## Comment on DE 2015-06 Northern Pass

Letter to DOT regarding NPT burial specs, sent January 3, 2017:

Figure 5-1: Typical Rig Side Work Area and Equipment Lay-Out for Large HDD Projects

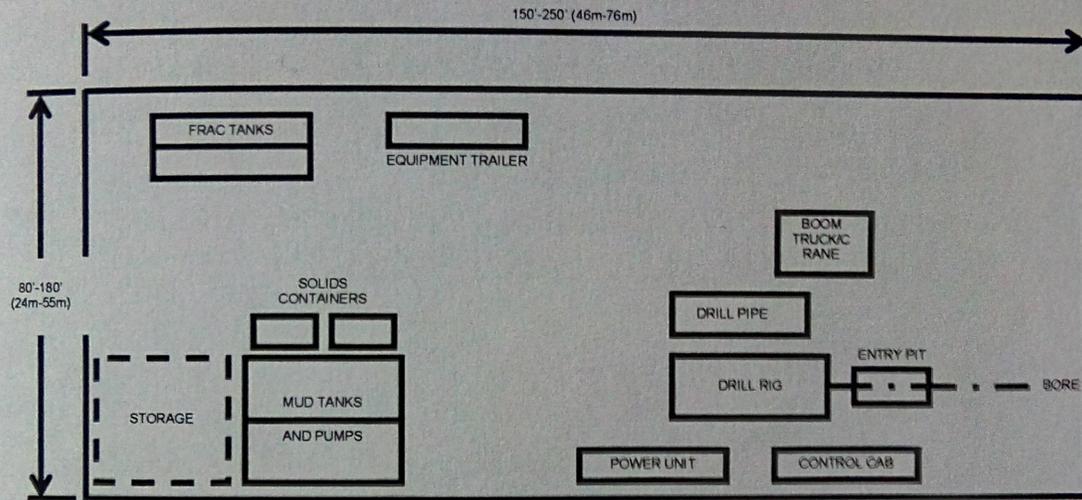
Being larger than 16', NPT fits into the large classification. And with two 18+" bores, what happens? One drilled at a time, perhaps doubling construction time?

Figure 5-1 shows a work space 80-180' wide and 150-250' long. Presumably the pipe layout area and exit area is another area, not shown.

Work area above: 80'-180' x 150'-250'
